## PIC24FJ64GA004 Family Silicon Errata and Data Sheet Clarification

The PIC24FJ64GA004 family devices that you have received conform functionally to the current Device Data Sheet (DS39881D), except for the anomalies described in this document.

## Data Sheet Clarifications

**FIGURE 2-3 FREQUENCY vs. ESR PERFORMANCE FOR SUGGESTED VCAP**

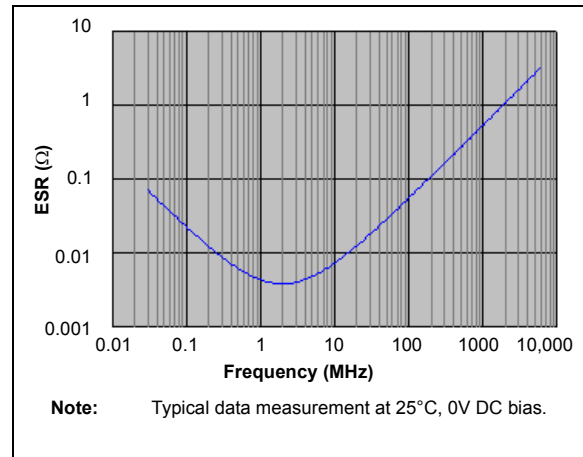
Designers may use [Figure 2-3](#) to evaluate ESR equivalence of candidate devices.

When the regulator is disabled, the VCAP/VDDCORE pin must be tied to a voltage supply at the VDDCORE level. Refer to **Section 27.0 “Electrical Characteristics”** for information on VDD and VDDCORE.

**FIGURE 2-4 DC BIAS VOLTAGE vs. CAPACITANCE CHARACTERISTICS**

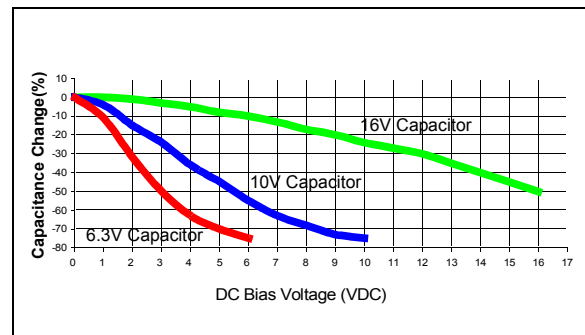
In addition to temperature tolerance, the effective capacitance of large value ceramic capacitors can vary substantially, based on the amount of DC voltage applied to the capacitor. This effect can be very significant, but is often overlooked or is not always documented.

A typical DC bias voltage vs. capacitance graph for 16V, 10V and 6.3V rated capacitors is shown in Figure 2-4.

When selecting a ceramic capacitor to be used with the internal voltage regulator, it is suggested to select a high-voltage rating, so that the operating voltage is a small percentage of the maximum rated capacitor voltage. For example, choose a ceramic capacitor rated at 16V for the 2.5V core voltage. Suggested capacitors are shown in Table 2-1.
